Client/Project
FWRN LP
Natural Heritage Assessment Report

**Reference: Natural Heritage Assessment Addendum - Technical and Project Design Changes
Niagara Region Wind Farm**

The purpose of this memo is to provide the Ministry of Natural Resources and Forestry (MNRF) with an addendum to the 'Natural Heritage Assessment and Environmental Impact Study for the Niagara Region Wind Farm' (Stantec, 2013) to address proposed modifications to the Niagara Region Wind Farm (NRWC, the 'Project').

Figure No.
2.1

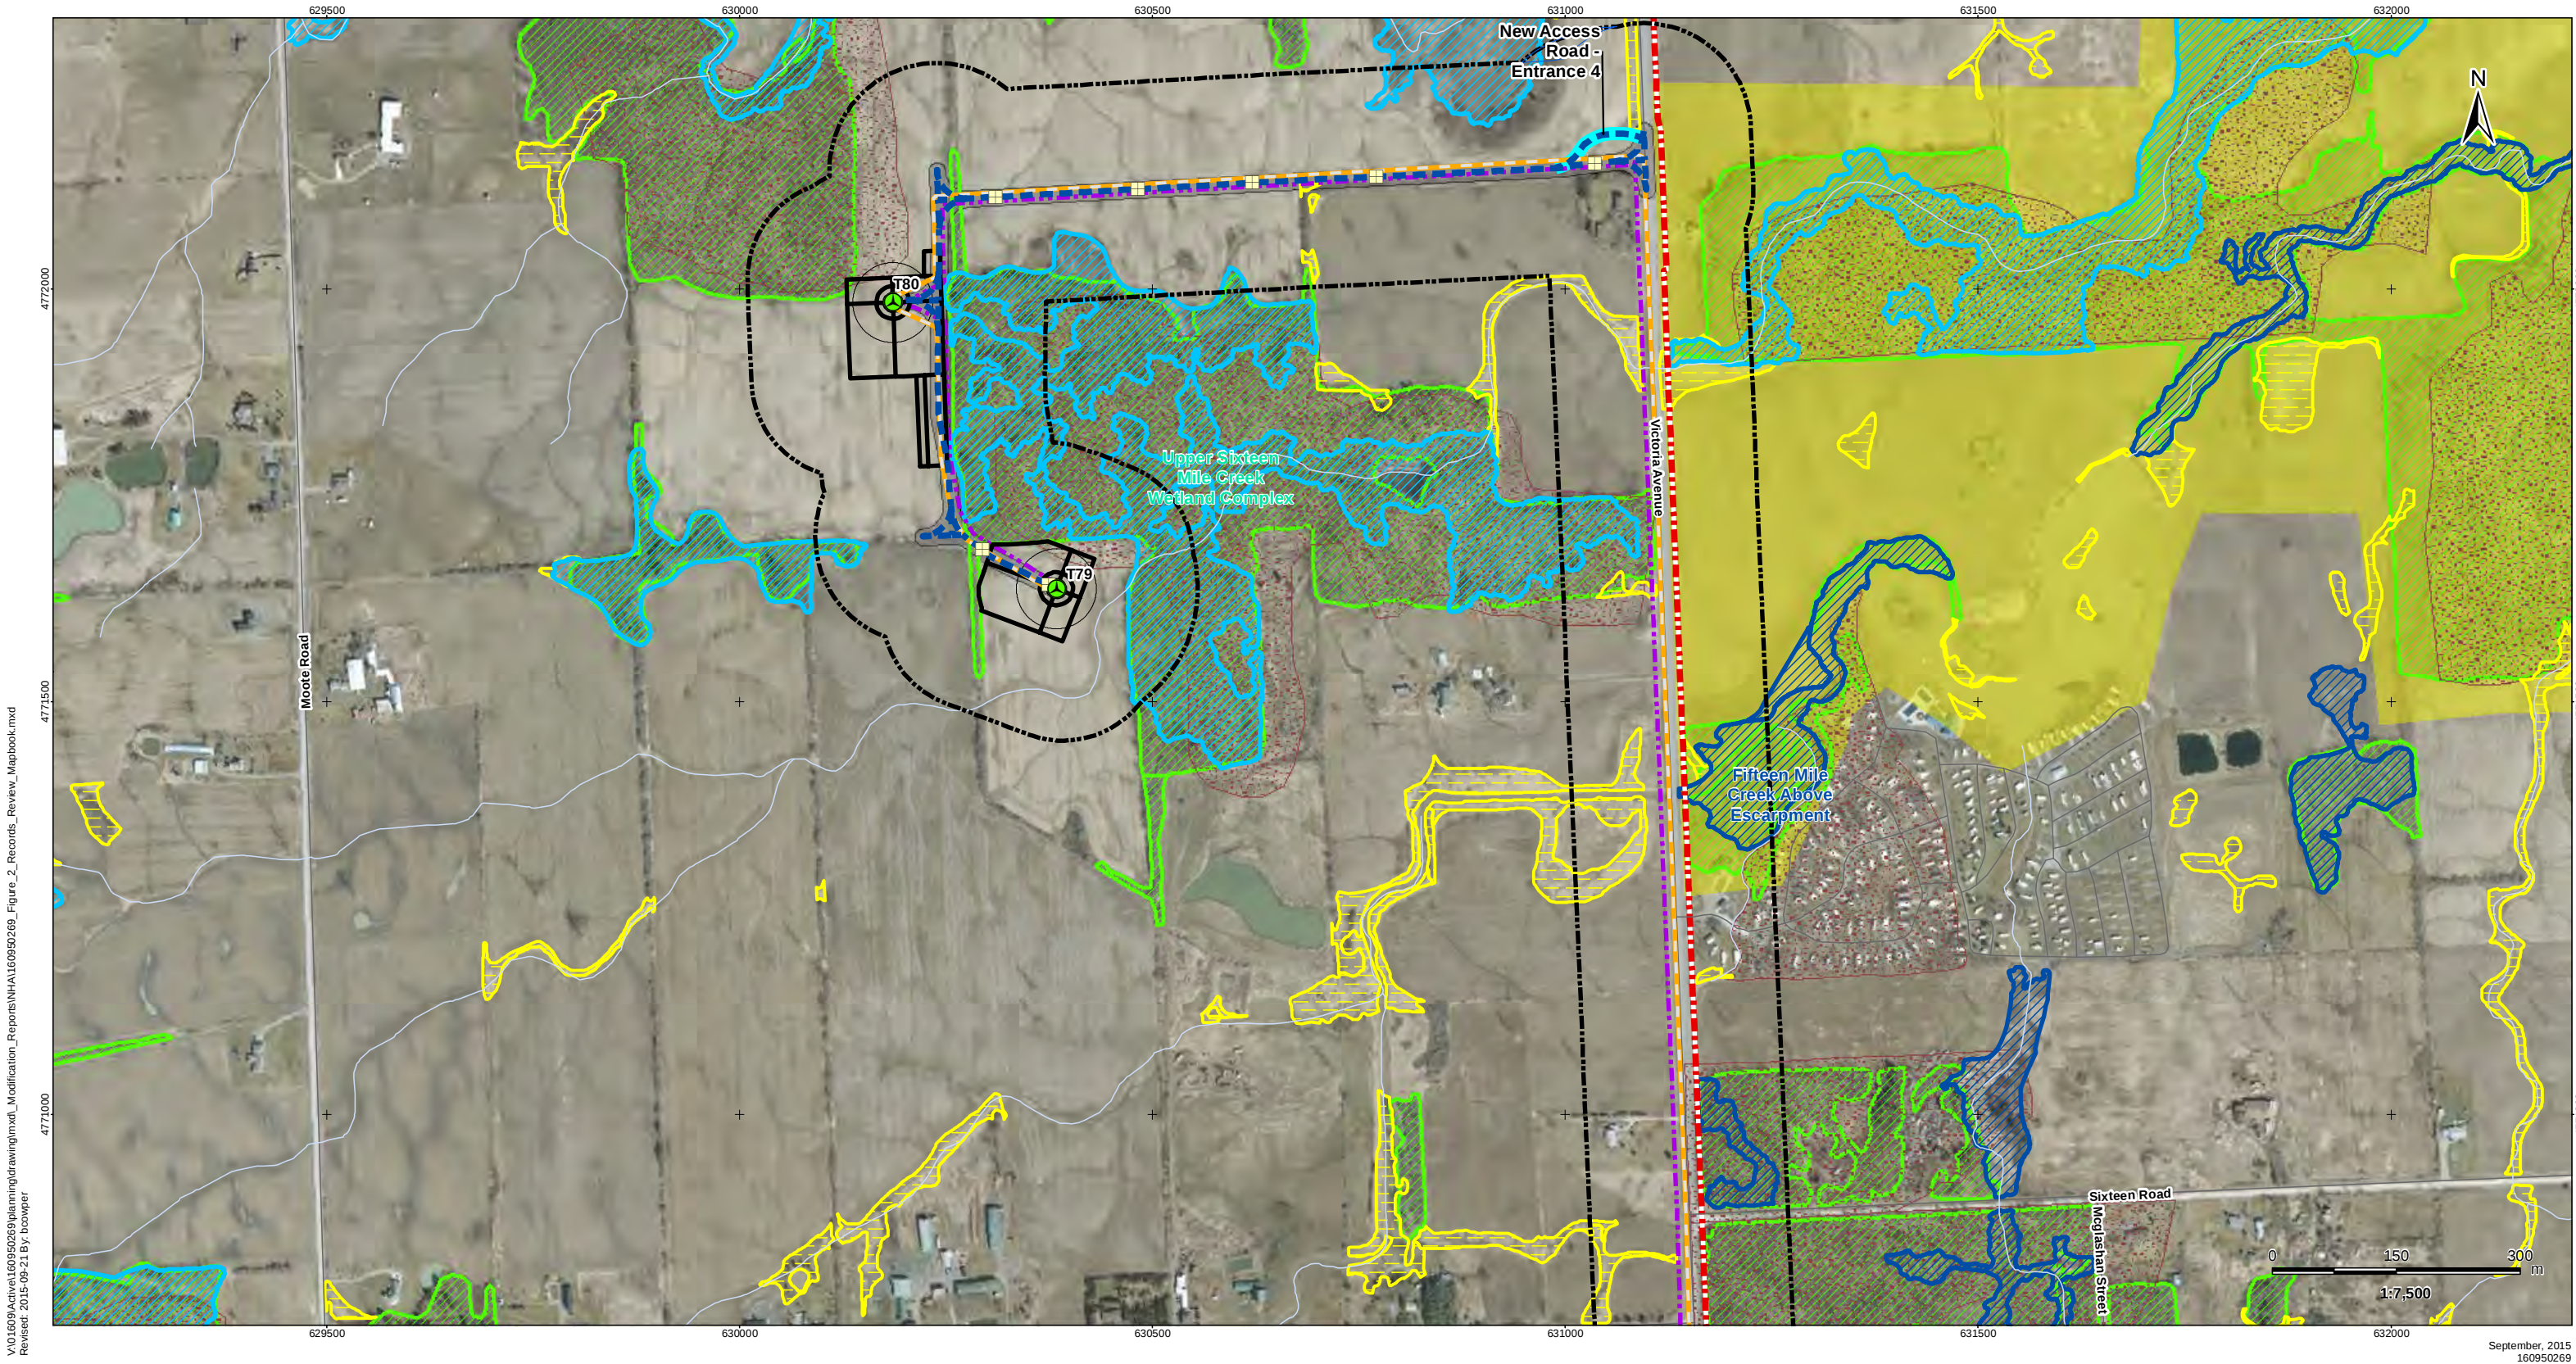
- A. Revised footprint of interconnection station to accommodate additional equipment requested by Hydro One Networks Inc. and associated construction area – this project design change does require a new ZOI area (**Figure 2.1, Attachment A**);
- B. Alternate access road between T12, T11, and T41 to avoid delivery of components from Gore A Road which was identified as a concern by Haldimand County – this project design change does require a new ZOI area (**Figure 2.43, Attachment A**);
- C. Revised footprint of north substation to avoid archaeological resources identified nearby – this technical change does not require a new ZOI area (**Figure 2.39, Attachment A**);
- D. Relocation of junction boxes to increase operational flexibility and help with municipal concerns of the current locations – this technical change does not require a new ZOI (text change only);

Figure No.
2.20

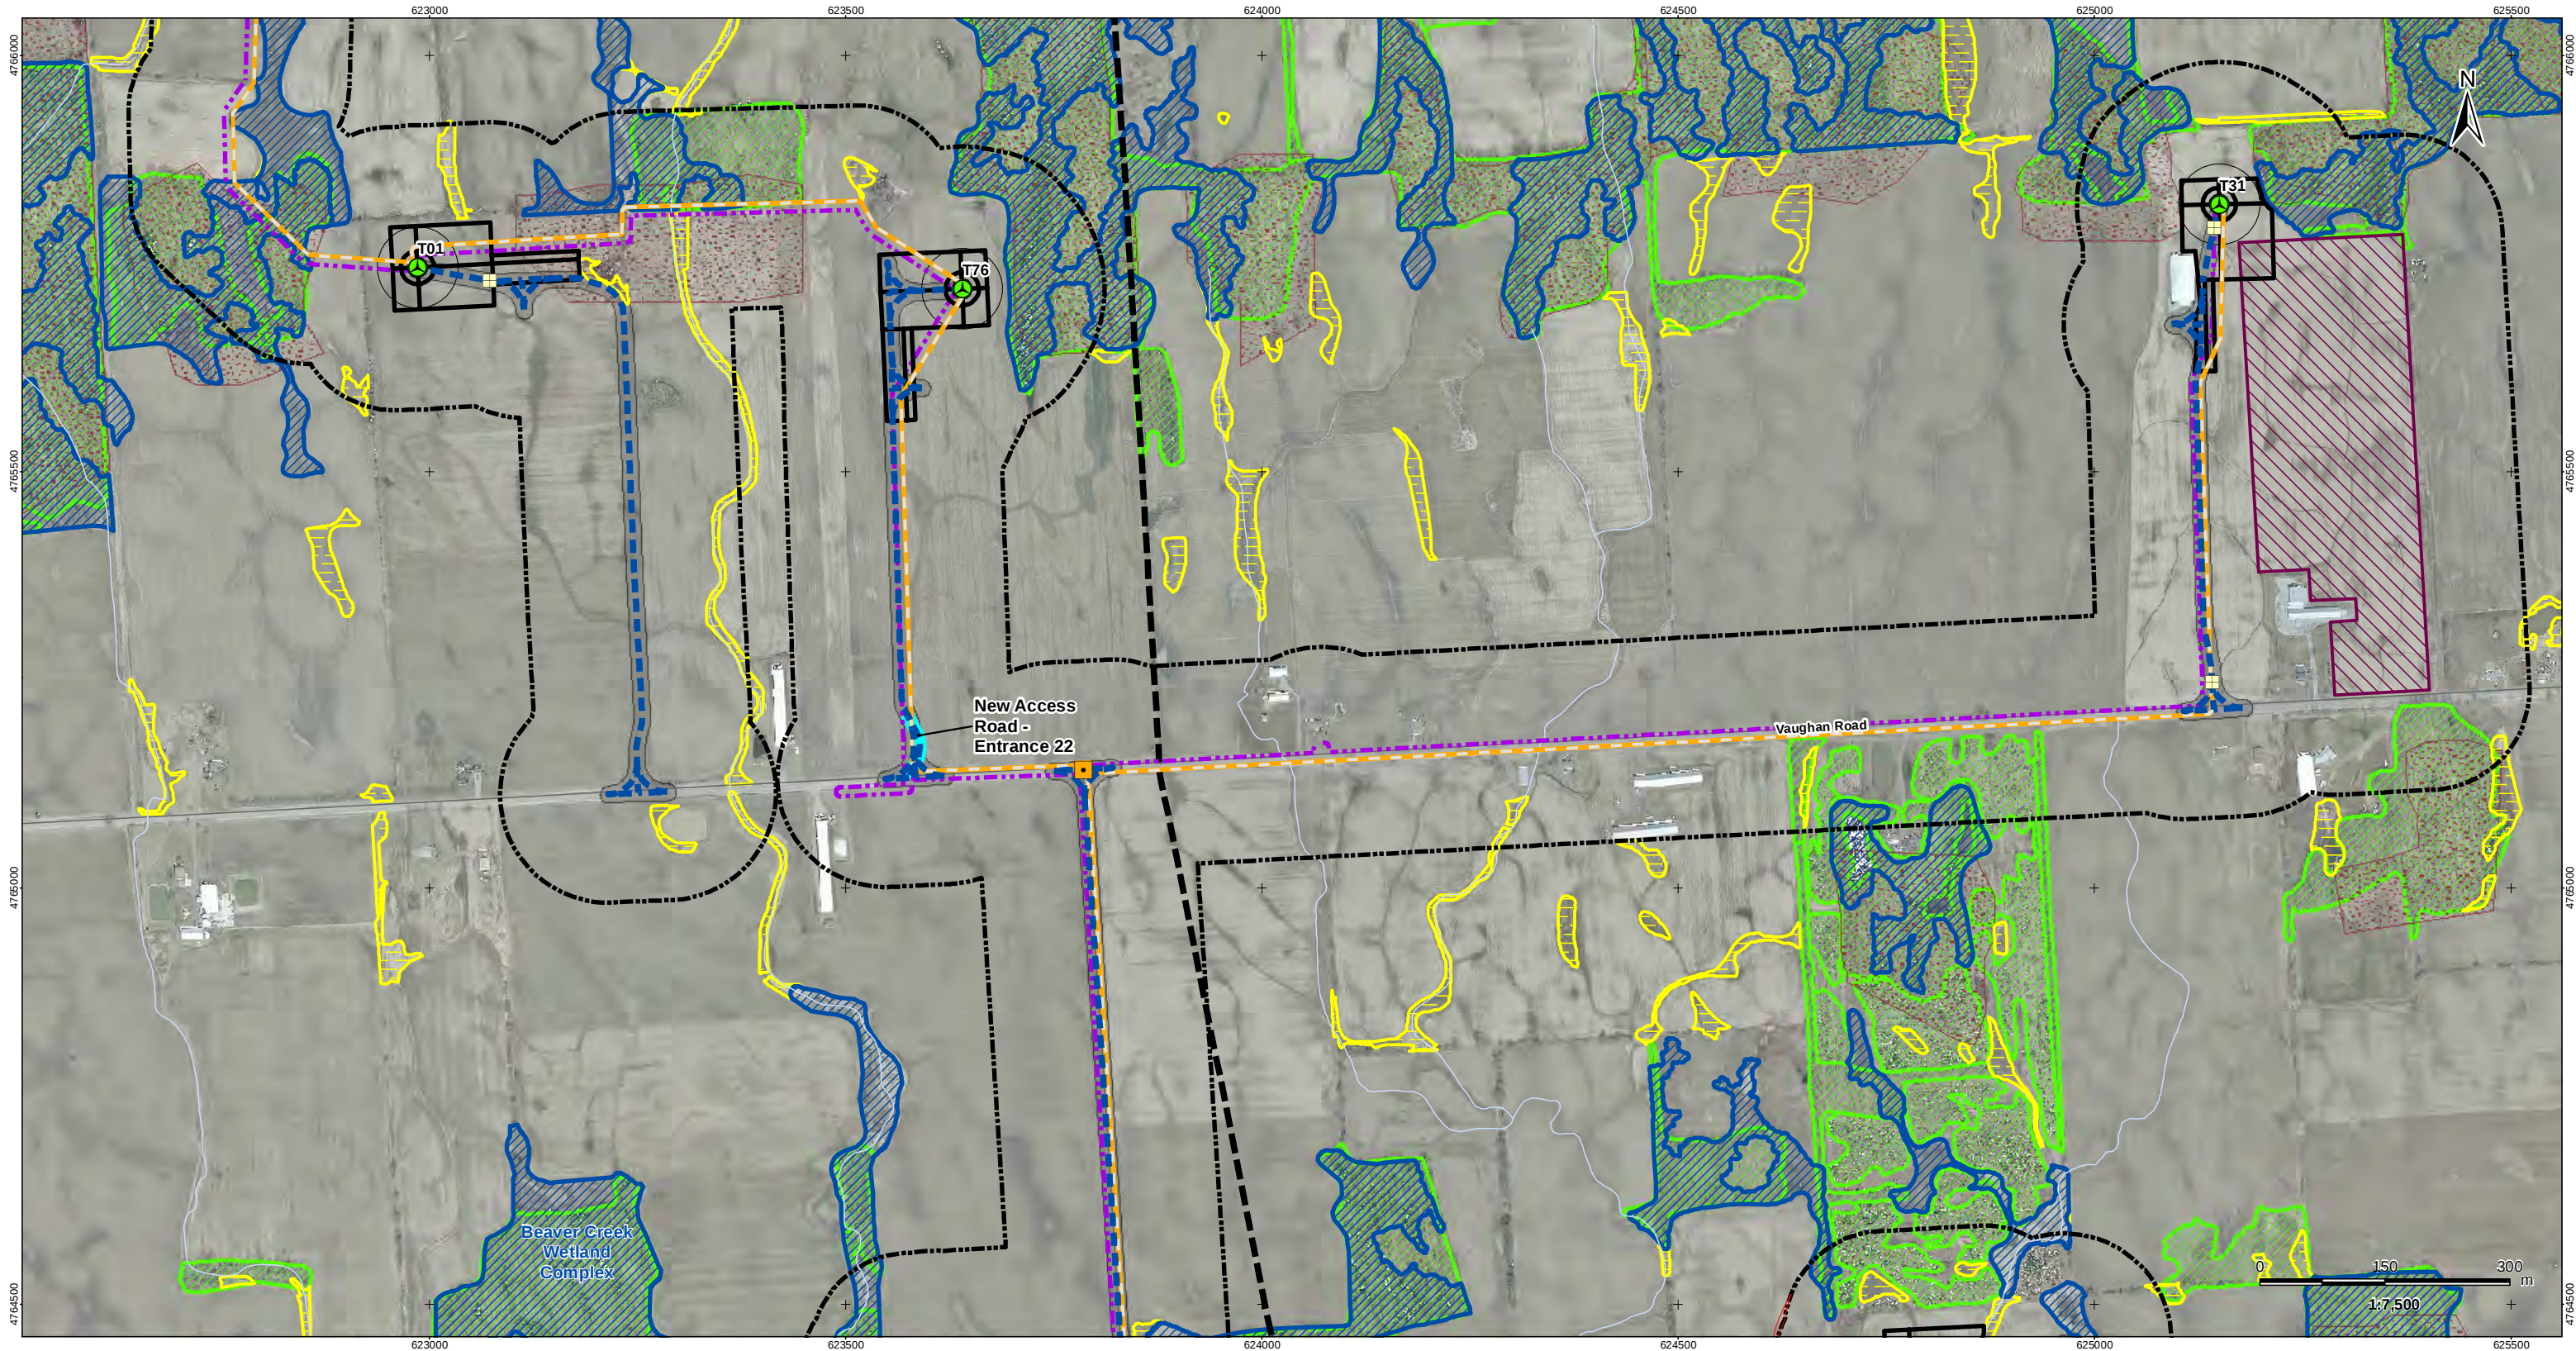
- G. Revised access road entrances (T79/T80, T76, T09/T51, T10/T37, T84, T99, and T20) to allow for increased turning radii for component delivery – this technical change does not require a new ZOI with the exception of the entrance to T79/80 (**Figures 2.20, 2.28, 2.35, 2.41, 2.48, and 2.54, Attachment A**).
